**H22-19**  
**Hotel Redevelopment**  
***REVISED***

Property Owner: Legacy Hotel of Medina LLC  
Applicant: Jim Gerspacher  
Location: 253 and 257 South Court Street  
Zoning: C-2 (Central Business)  
Request: Certificate of Appropriateness revisions for the construction of a hotel

The current application revises the footprint and height of the hotel building, updates building elevations, and provides greater detail. The proposed revision does not alter the previous approval regarding the demolition of two existing buildings at 253 and 257 South Court Street or application H24-06.

This letter is regarding the proposed hotel on parcel 028-19A-21-397. Our team has been working on adjustments to the overall building design to improve constructability, enhance the floor plans for both operational efficiency and guest experience, as well as enhance the exterior design and compatibility within the Historic District.

LANDSCAPE  
SITE PLAN

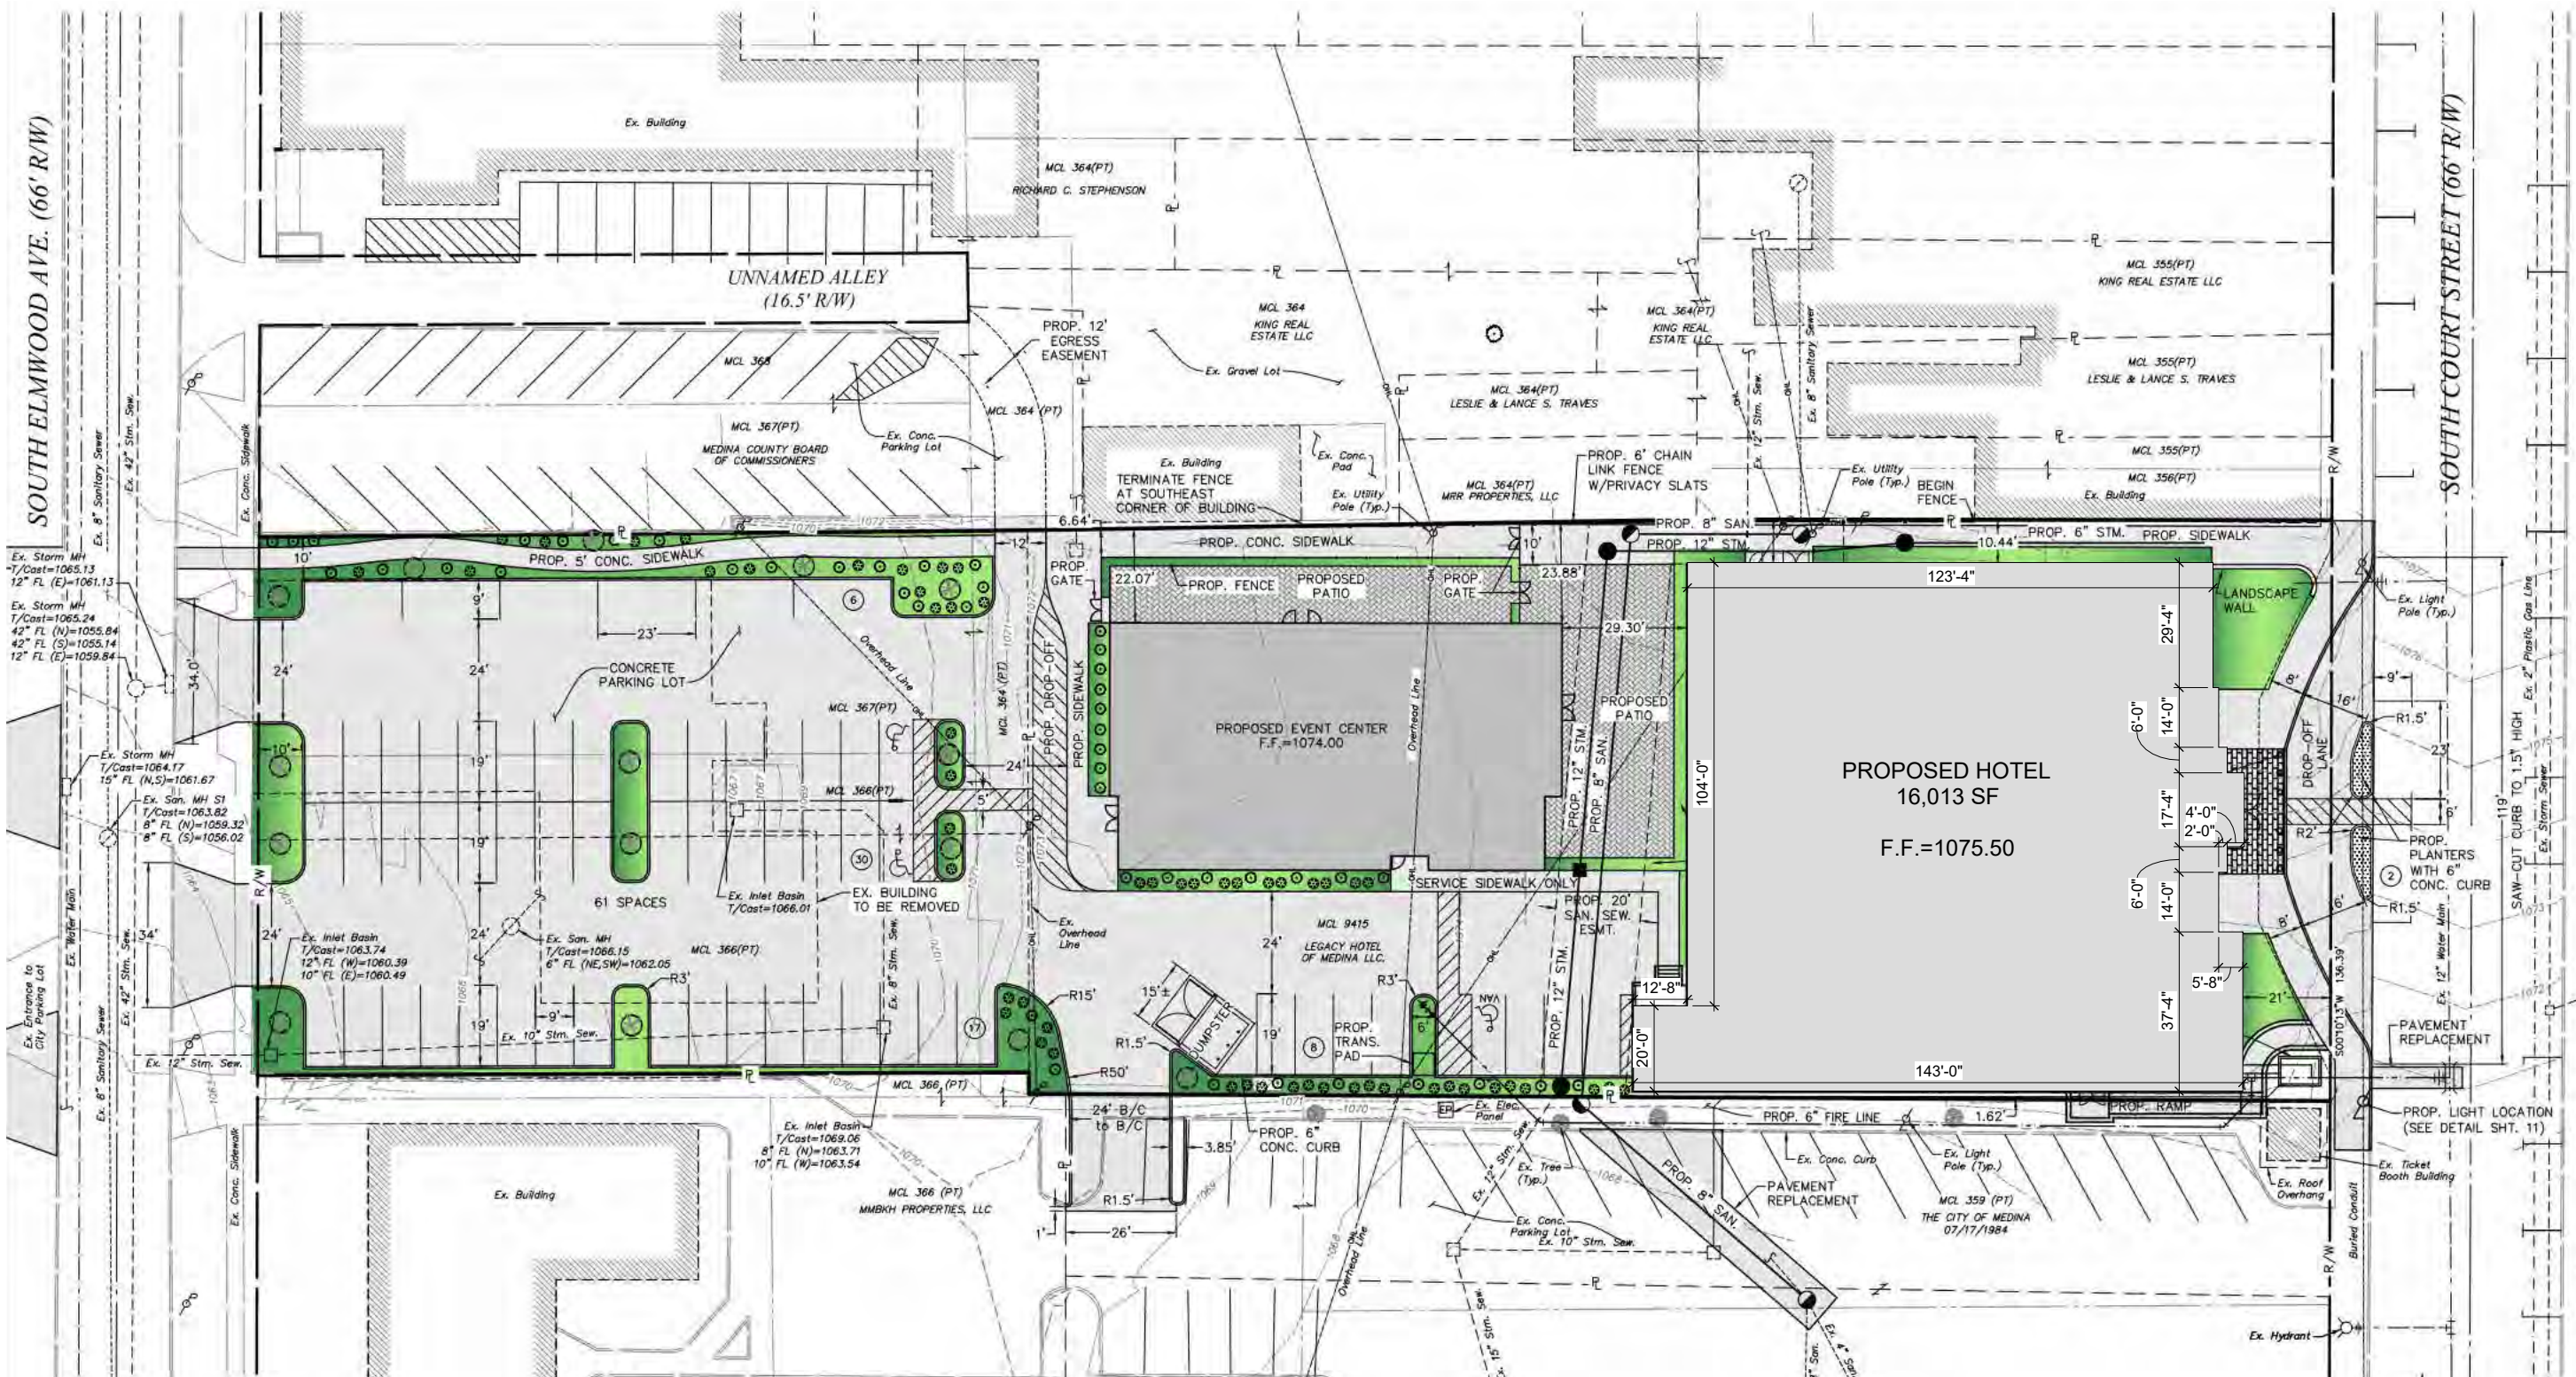
The landscaping plan has been revised slightly to include landscaping on the north side of the hotel.

**1 PLAN** ROOF PLAN OUTLINE AND HEIGHTS  
1" = 20'-0"

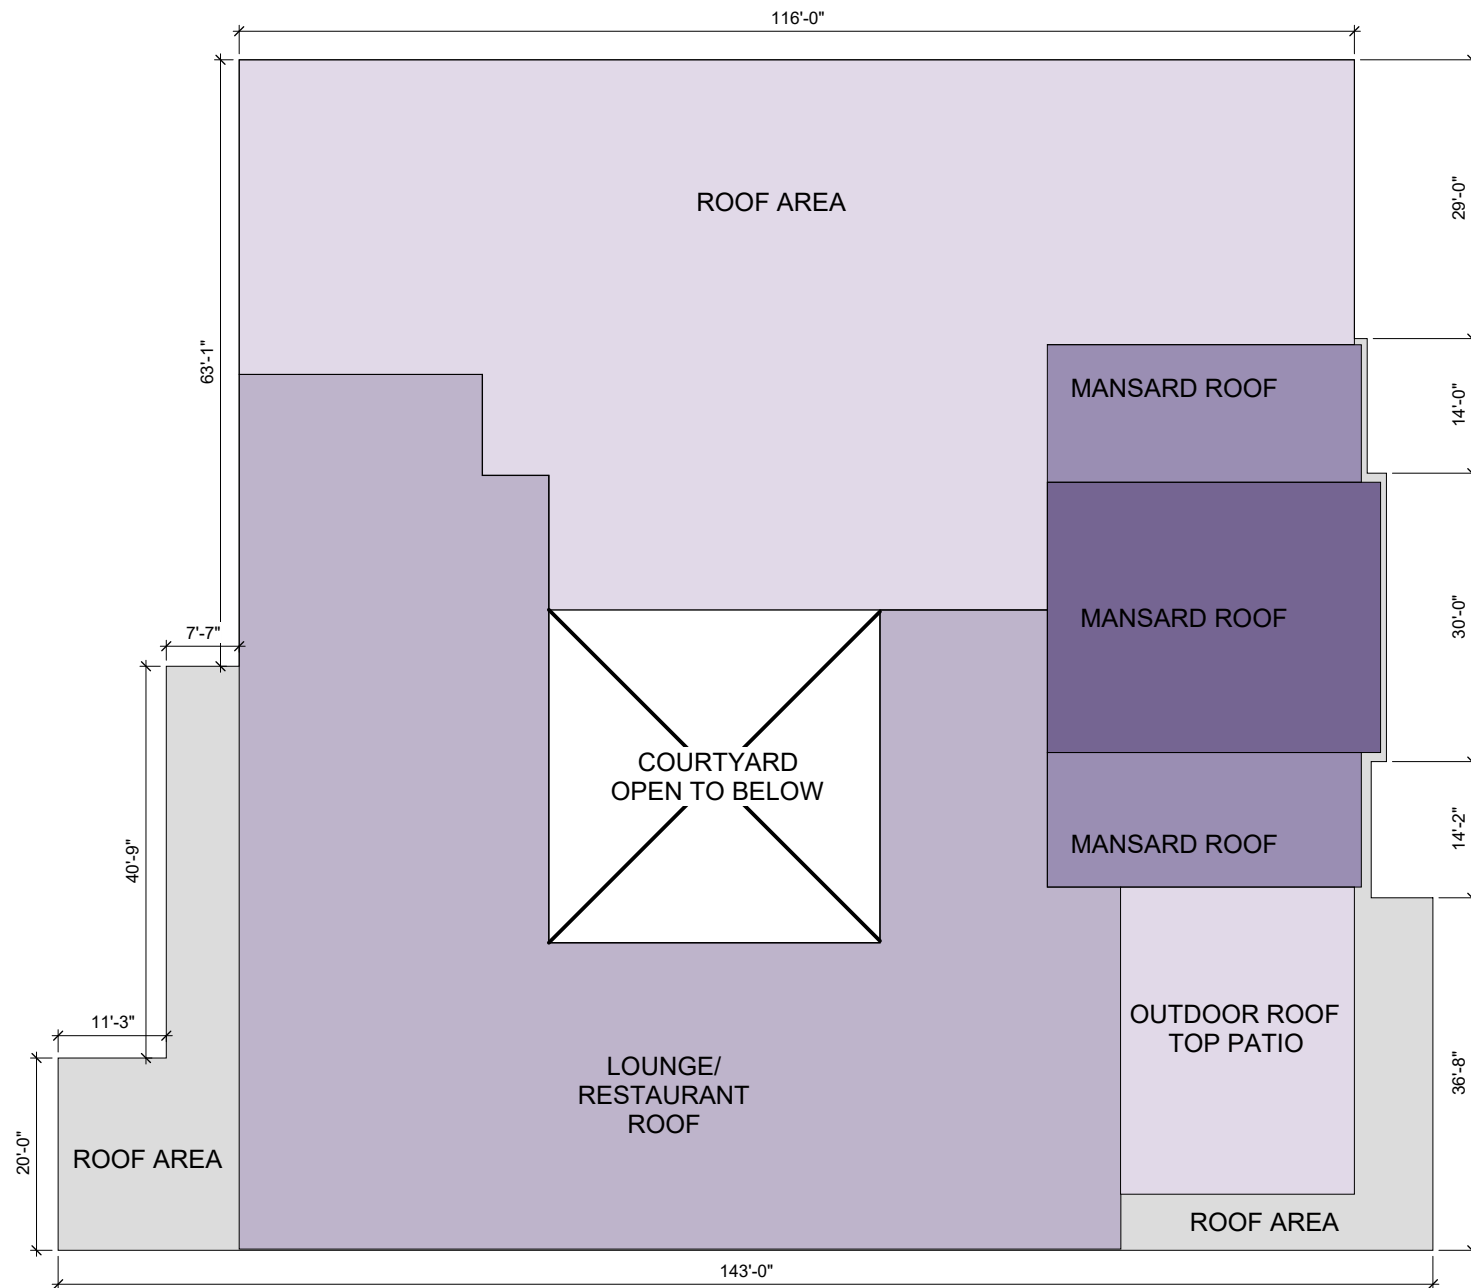
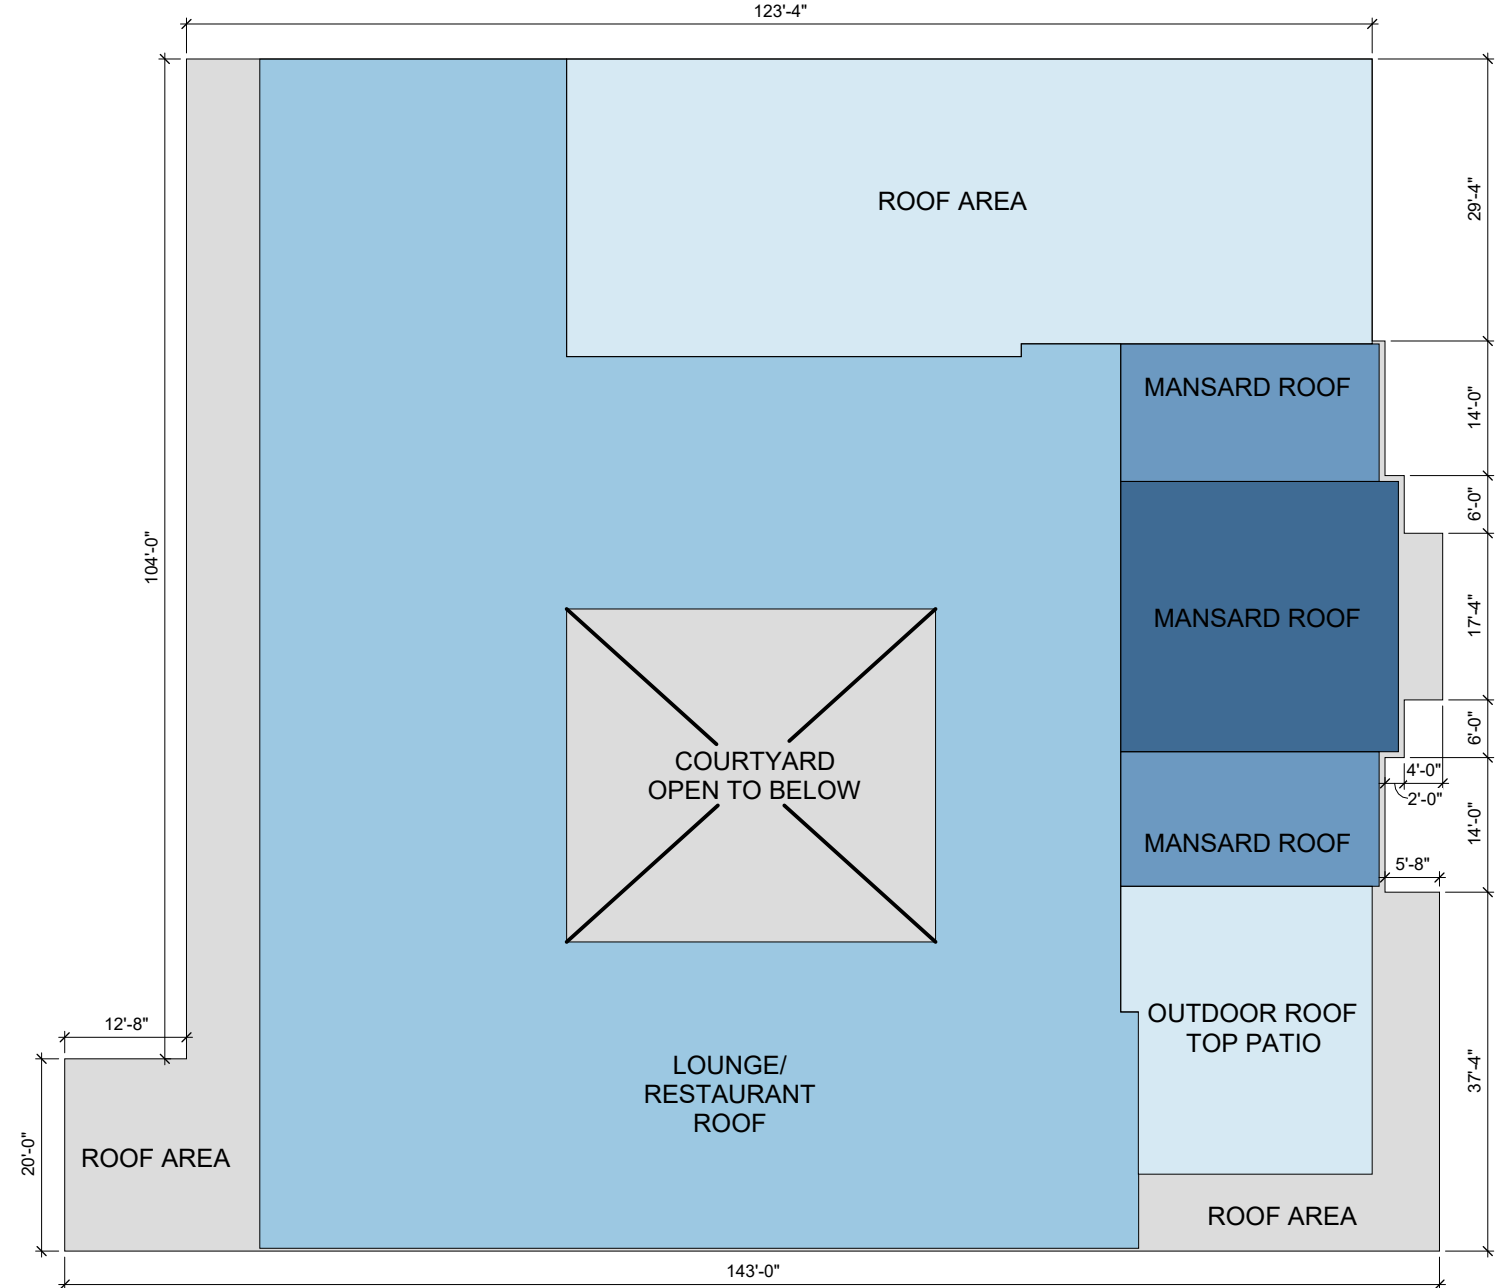
The overall effective height of the building has increased by 6 ft. to sufficiently accommodate mechanical components. The effective height of the revised building is 61 ft., which is the roof line of the building. Decorative architectural features that do not have functional interior area above this height are not included in the effective height of the building.

- 2- Height increase: the original approved elevations show the top of roof at 55'-0", the updated drawings show 61'-0". The additional height requested is 6'-0" higher than the previously approved plans. This increase in floor height accommodates more advanced HVAC systems than previously approved without sacrificing quality of interior spaces. Unlike the previous design, no suites will have exterior louvered grilles on the newly proposed plans. Without the new height variance, the available methods of construction are narrowed to options that are not as feasible and accommodating mechanical duct work becomes difficult.

The mansard roof was previously approved at 66'-8", the proposed is at 71'-0". This is purely an architectural feature that gives the hotel its historical character and is visible on S Court Street from all sides. The added height is not being used to generate profit to the developer(s).

ELEVATION HOTEL - EAST ELEVATION

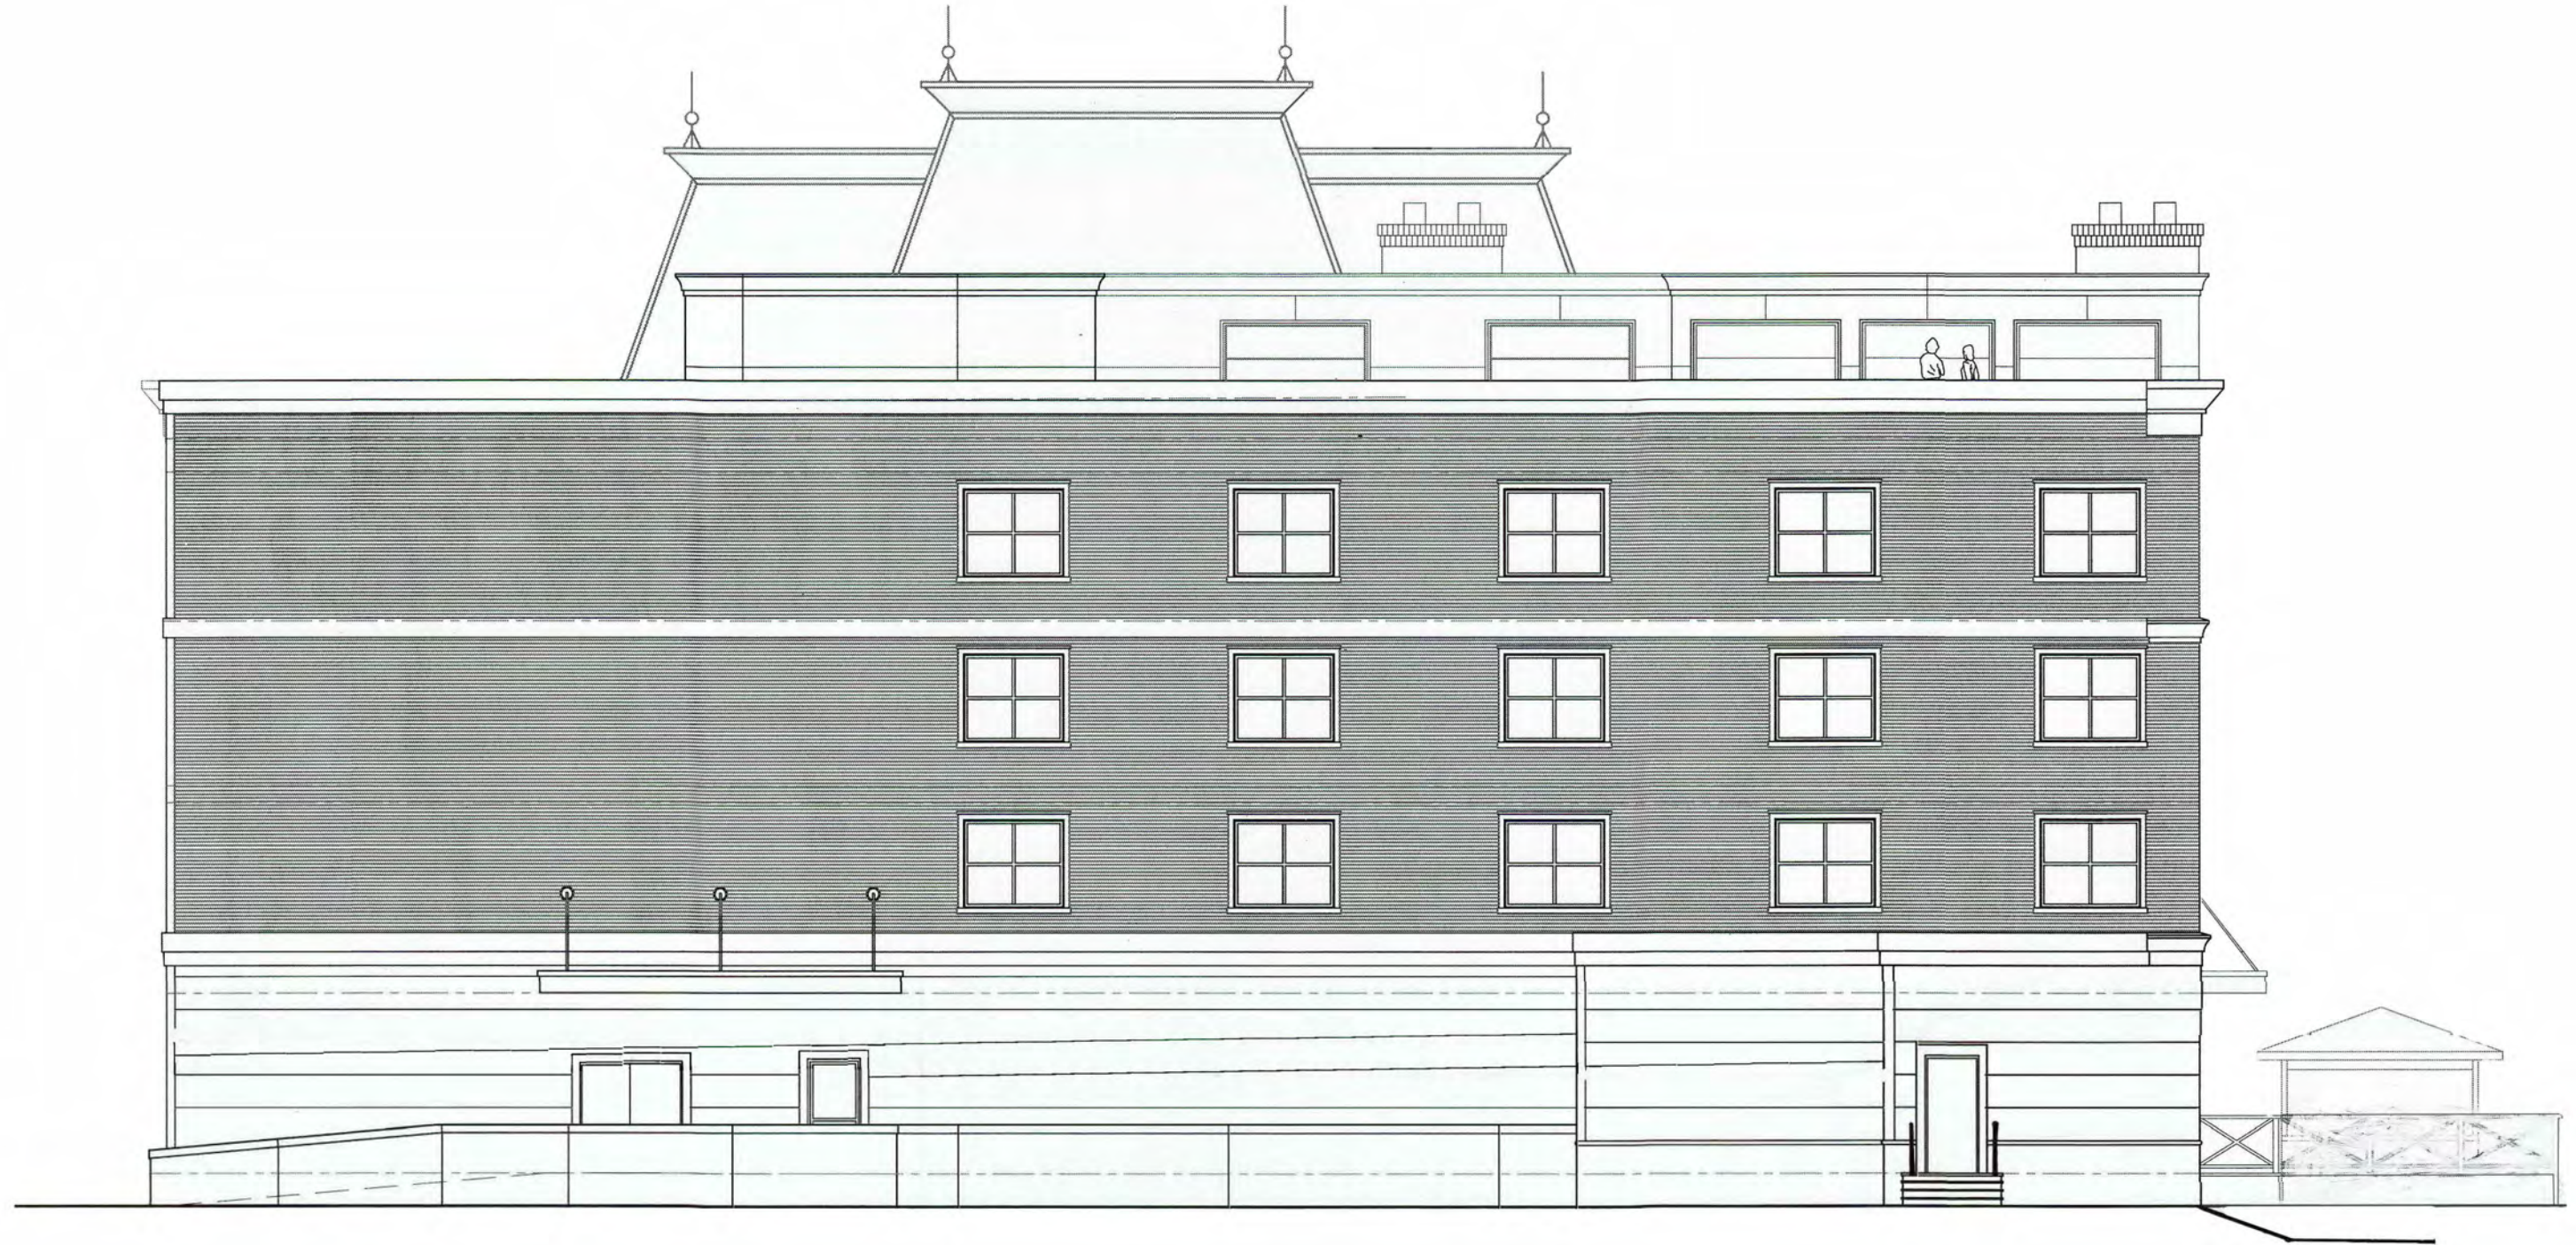
- 1- Brick detail added on all facades, especially primary façade (Brick reveals and soldier courses)
- 2- VTAC louvers have been eliminated on north and south facades.
- 3- Window size and shape: In the previously approved design, each hotel suite has a single wide and low window. The proposed design replaces that single window with two tall and slender windows per suite to better fit proportionally within the context of Medina's Historic District.
- 4- Replace the use of EIFS with Fiber cement (for maintenance and durability purposes - similar color) on the fifth floor.
- 5- The front canopy is reduced in size.
- 6- Cornice updates: We have assigned Sherwin William color codes to the previously submitted cornice colors to better define the selections. We have also updated the configuration of the colors on the cornice profiles.
